## **REMARKS**

Appl. No. 10/027,296  
Amdt. Dated June 16, 2003  
Reply to Office Action of March 31, 2003

**FIG. 2a**

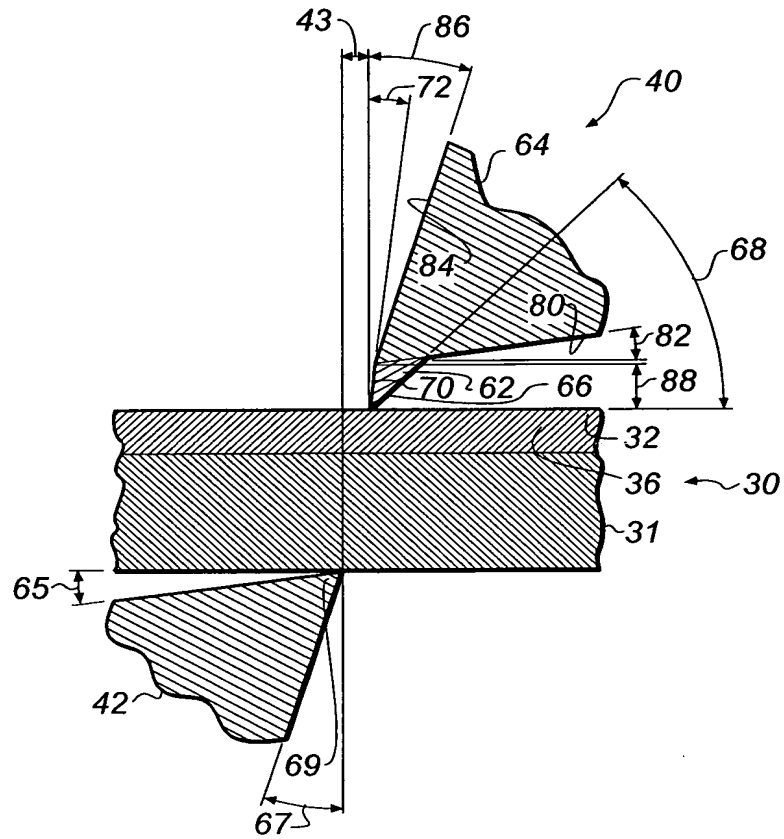
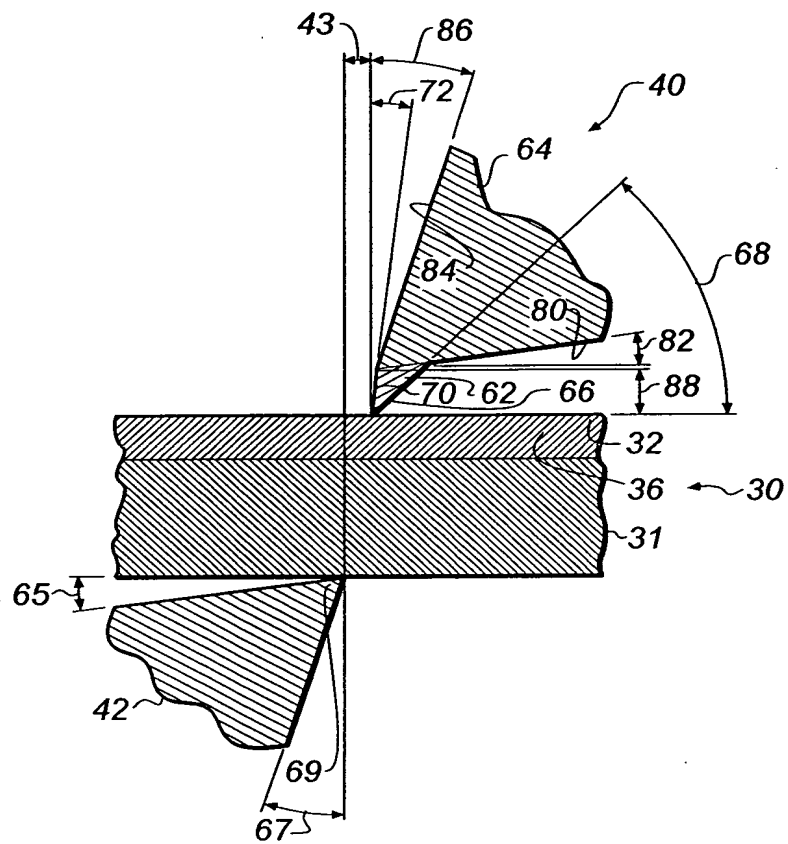
The drawings are objected to for not labeling Figs. 4, 5(a) and 5(b) as prior art. The drawings are hereby corrected accordingly. The drawings were also rejected for not showing a second crack initiator on the second cutter blade as claimed in claim 4. A new Fig. 2(a) is provided to show this feature. Also, the specification is hereby amended to include a reference to new Fig. 2(a) and to include a discussion of new Fig. 2(a) in the Detailed Description of the Invention. Support for this amendment is found in original claim 4, no new matter having been added.
